PROJECT TECHNICAL MEMORANDUM

JOB TITLE : Slate Wharf
REF : HT: 28795/PTM2
DATE : 28 July 2023
FROM : George Grenfell
ISSUED TO : Matthew Fisher

RE: SLATE WHARF NOISE IMPACT ASSESSMENT - ADDENDUM

Typical floor plan highlighting the south-side bedroom windows subject to fan noise from 'The Wharf'

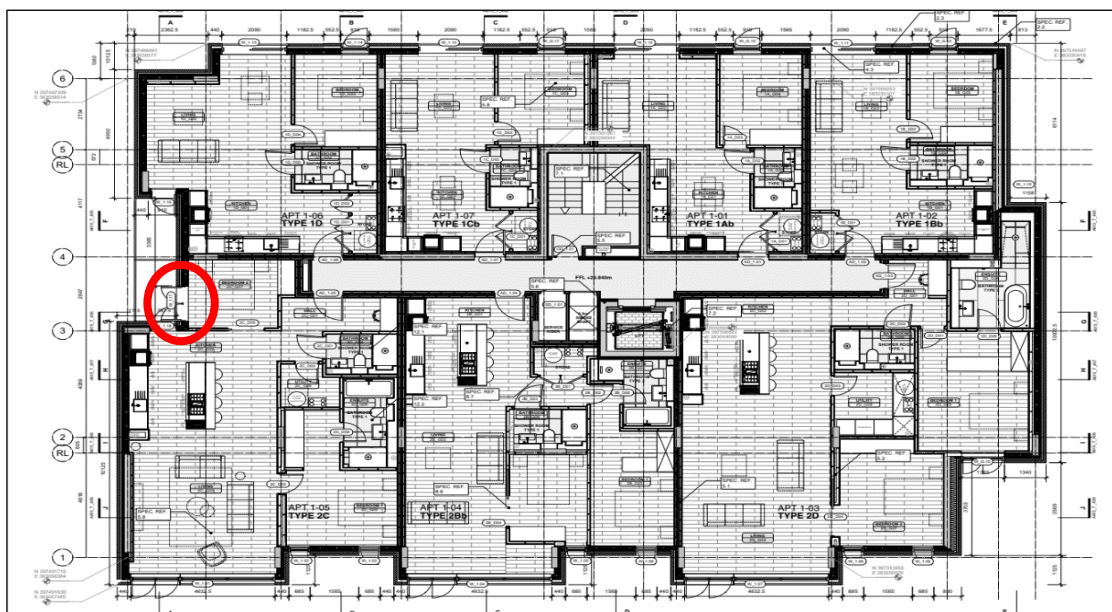
1) "The proposed glazing selected does not meet the performance criteria in the South façade bedrooms. These will need be upgraded to meet the require specification of a minimum of 35dB R_w) Examples of the glazing system that will meet the requirement for this location will need to be provided by the consultant. Suggestion has been made that secondary glazing may be installed. If this is the case (although not preferred) then performance and examples of the secondary glazing system needs to be recommended along with construction / fitting recommendations to ensure the secondary glazing is sufficient to meet the performance requirements."

As indicated above, the south side bedroom window was given an uplift in specification to 35dB $R_w + C_{tr}$, to directly mitigate extract fan noise from the adjacent Public House 'The Wharf'. This south side window is highlighted red in the plan below:

As noted in MCC's comment 1, it has been observed that the glazing selected for the south-side bedrooms does not fully align with the recommendations outlined in the previously issued Noise Impact Assessment.

To address comment 2, a sample of internal noise level measurements was conducted during daytime periods, specifically when The Wharf fan is operational. The objective of these measurements was to assess and confirm the effectiveness of the as-built façade in adequately mitigating noise ingress from all external sources.

Hann Tucker attended site on 22nd June 2023 to undertake a range of internal ambient noise level measurements to validate the sound insulation performance of critical façade elements. L_{Aeq} measurements were taken over 1-minute periods in each of the 4no. south-side bedrooms to assess the performance of the installed glazing. The results are presented in the table below:

As presented in the preceding table, it is evident that all south-side bedrooms, which represent the worst-case scenarios in terms of external noise ingress, have demonstrated compliance with the BS8233 criteria for internal ambient noise levels during daytime periods. Consequently, each of these bedrooms meets the requirements set forth by the Local Planning Authority (LPA).

In conclusion, the installed glazing has proven to be effective in efficiently mitigating noise intrusion, successfully maintaining internal noise levels below the statutory limits.
